Preliminary Consultation
MONTGOMERY COUNTY HISTORIC PRESERVATION COMMISSION
STAFF REPORT

Address:	10305 Armory Avenue, Kensington	Meeting Date:	5/22/2024
Resource:	Primary Two Resource Kensington Historic District	Report Date:	5/15/2024
Applicant:	Village Concrete (Agostino Costa, Agent)	Public Notice:	5/8/2024
Review:	Preliminary Consultation	Tax Credit:	Partial
Permit Number:	n/a	Staff:	Chris Berger
PROPOSAL:	Demolition, two-story rear addition, and various alterations.

10305 ARMORY AVE HAWP PRELIM SUBMISSION

Figure 6: The existing site plan (left) and proposed site plan (right).

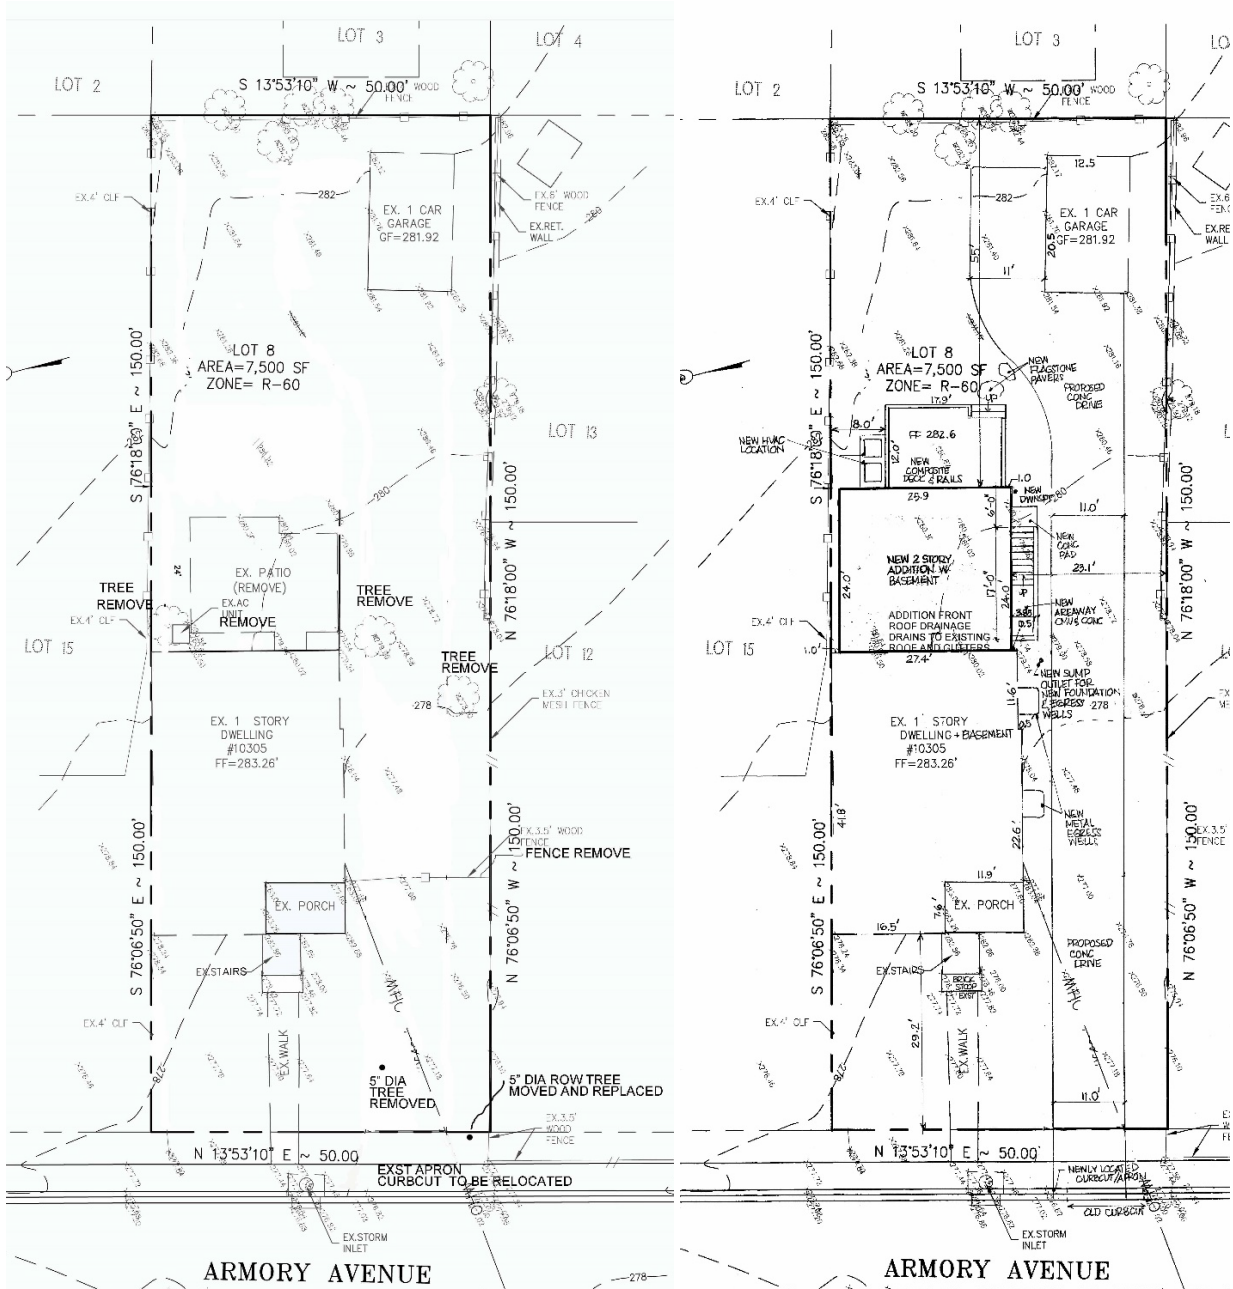
Staff supports all proposed changes to the landscaping and hardscaping and finds the work will not substantially alter the historic resource and is compatible. This includes removal of the brick patio; deck construction; areaway construction; tree removals; new curb cut and driveway; stone pavers; fence segment removal, and installation of HVAC units.

Staff requests an arborist report for the trees to be removed.

Staff encourages the applicant to reduce the driveway in width from 11 feet as proposed to minimize the amount of pavement added to the property.

Staff seeks more detailed plans for the areaway and deck in future versions of the project.

Figure 7: The existing and proposed front elevation.

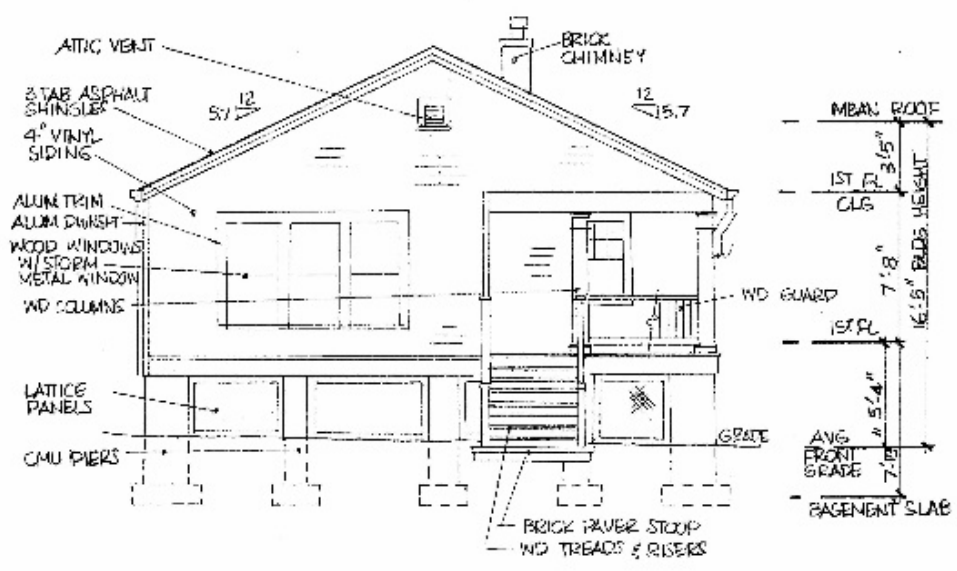
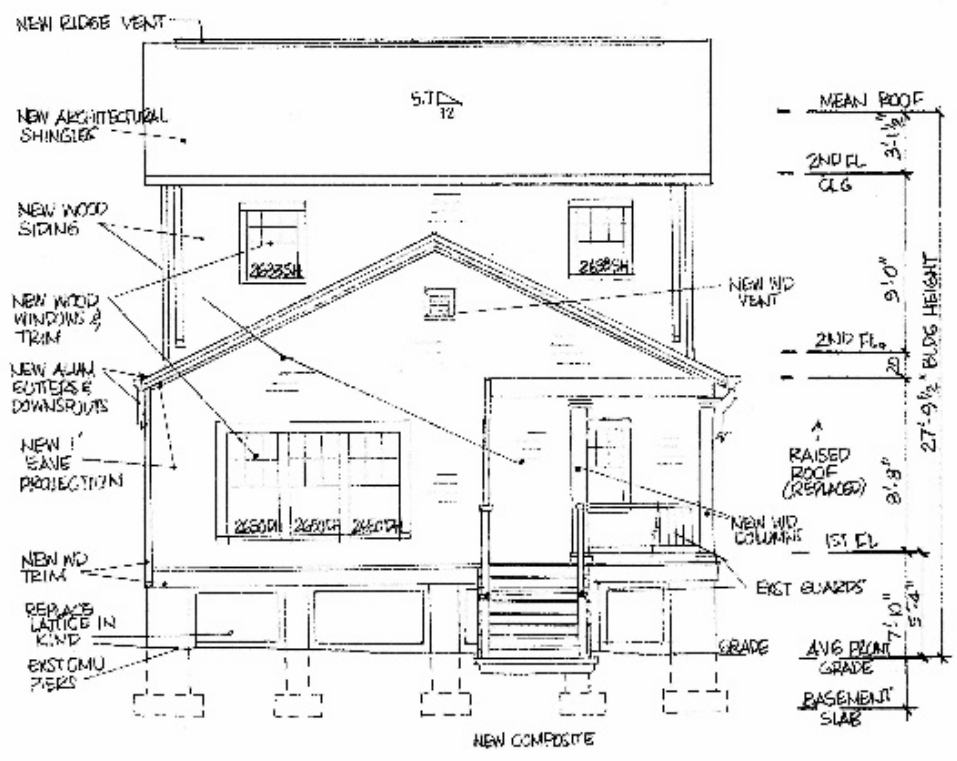
Staff does not support a number of the alterations proposed for the existing resource, including raising the roof; removing the chimney; adding an eave on the front of the building; replacing the wood porch floor with composite; installation of wood windows on the front elevation; installation of composite windows on the side elevation; infilling two windows and enlarging four others on the right-side elevation; installation of composite windows on the side elevations; and replacing the front wood stairs with composite. While 10305 Armory Avenue is of a simple design and has been altered, it is a Primary Two Resource in the Kensington Historic District and alterations that further damage the building's form and character should be avoided. Staff finds that all this proposed work conflicts with Chapter 24A-8(b) of the County Code because they will substantially alter the exterior features of the resource and are incompatible with its character. The proposals also run counter to the *Standards*, which call for alterations that do not destroy the historic character of the property. Staff instead recommends the applicant retain and repair the chimney, porch floor, windows, and porch stairs and not complete the other work that would alter the building's appearance.

- Provide justification for the 1-foot eave extension. We prefer it not be extended but are open to your rationale. [OVER TIME THERE TENDS TO BE DAMAGE TO GABLE WALLS WHEN NO EAVE EXSTS \(CURRENT HOUSE SHOWS THIS\) , SO OWNER/CONTRACTOR WAS TRYING TO AVOID.](#)

- Keep the stained-glass window in its existing location or find a location elsewhere on the house to reinstall it. [WINDOW NOW SHOWN IN EXISTING LOCATION](#)

Figure 8: The existing and proposed rear elevations.

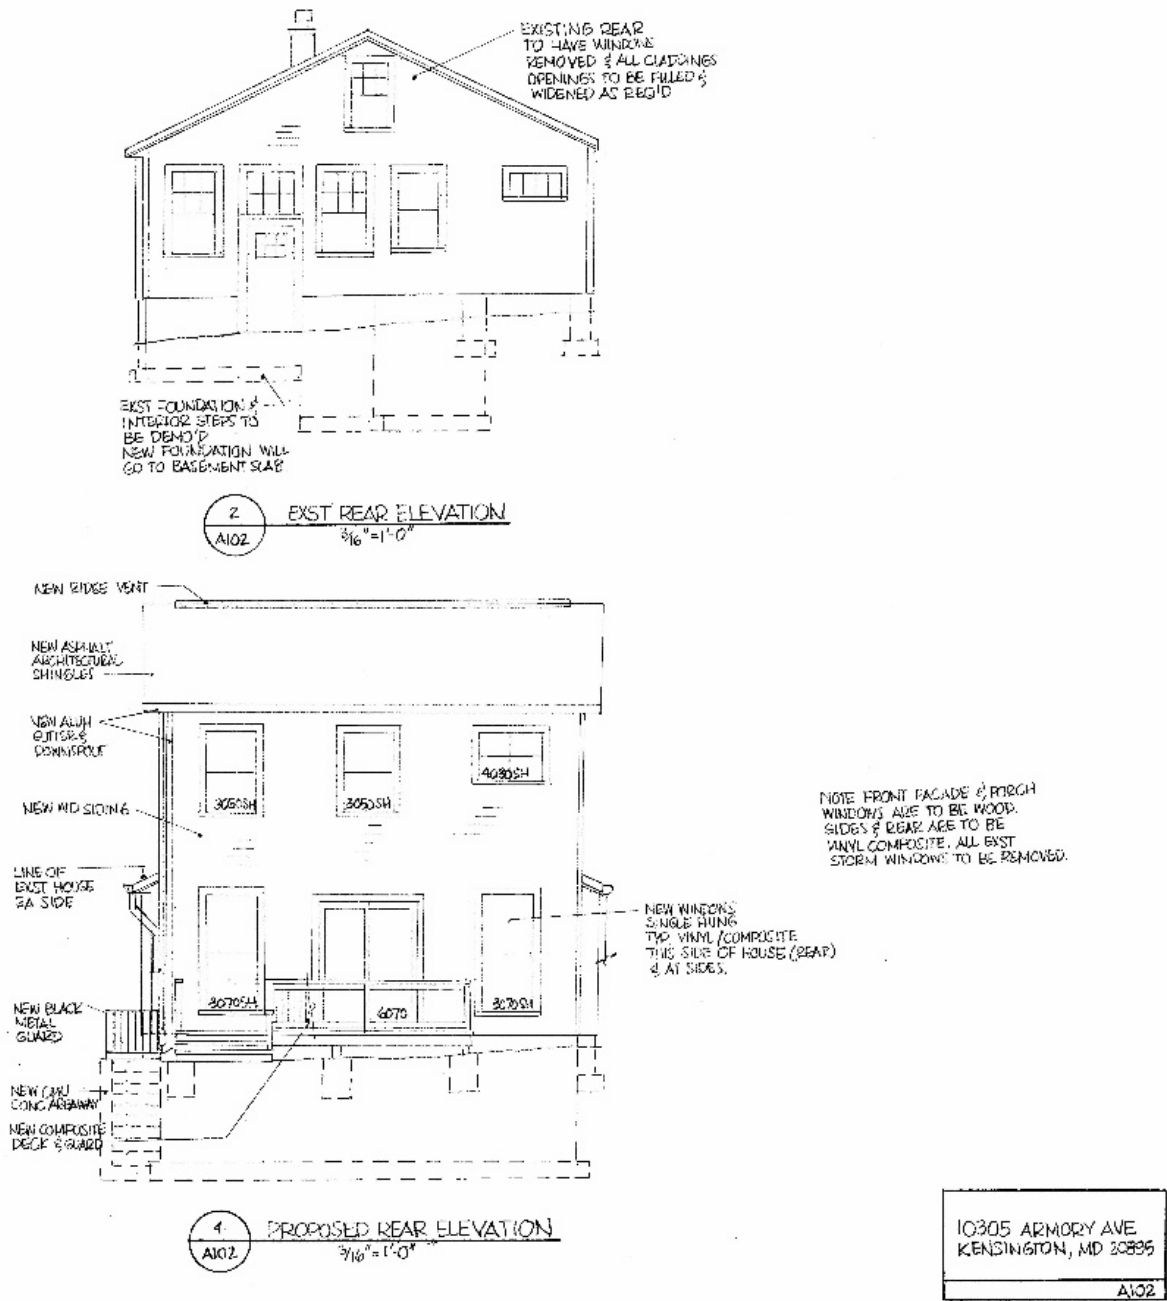
Staff supports a rear addition at this property, but not as proposed. In conflict with Chapter 24A-8(b)(2), the proposal is incompatible in character with the architectural features of the historic resource. And contrary to Standards #9 for new additions, staff finds the size, scale, and architectural features incompatible to the existing 1.5-story building. The new addition will be approximately 11-feet taller than the existing construction, and staff recommends the addition be reduced in height so it does not visually overpower the existing construction—especially if the roof on the existing residence is not raised one-foot as staff recommends. Further, staff finds the front-oriented gable roof clashes with the side-oriented gable roof on the existing building and recommends the roof orientations match. Staff also seeks evenly spaced window openings on the addition, particularly on the existing side elevations.

Staff supports the pitch of the addition's roof and its covering with architectural grade shingles. Staff also supports the differentiation created by the addition's wider roof overhangs. Staff seeks wood or aluminum clad wood windows on the addition and not the composite windows as proposed. Staff is supportive of the sliding door on the new rear elevation. A window a door schedule should be provided as part of future versions of the plan.

- Inset the rear addition at least 6 inches on both sides. [EXECUTED ON DRAWINGS](#)
- You should restore the existing wood windows. Window restoration is eligible for both 20 percent state historic tax credit and 25 percent county historic tax credit. [THE OWNER /CONTRACTOR FEELS THE WINDOWS NEED TO BE REPLACED AND IS HOPING TO PROVIDE ALL NEW WITH WOOD ONLY ON THE FRONT.](#)

Figure 10: The existing and proposed right-side elevations.

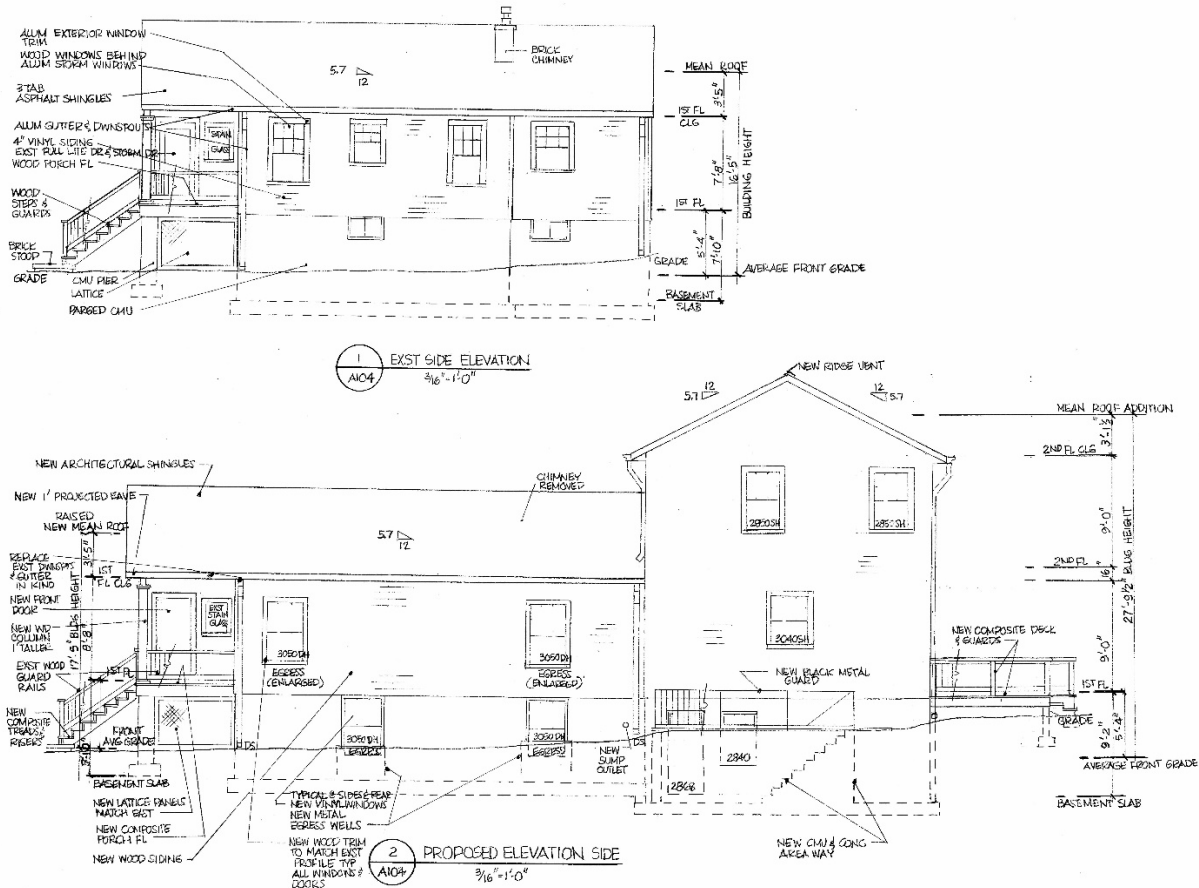
Staff in theory supports installation of window wells on the right-side elevation so the applicant can add bedrooms to the basement. The changes would not substantially alter the resource and are necessary to improve the livability of the building. More detailed drawings of the wells are necessary for staff to comment on the design.

- Window sizes should be maintained on the front elevation. Ideally, the windows on the side elevations will remain unchanged as well. [WINDOW SIZES RETAINED EXCEPT AT EGRESS WINDOWS FOR BEDROOMS AT FIRST FLOOR AND BASEMENT.](#)
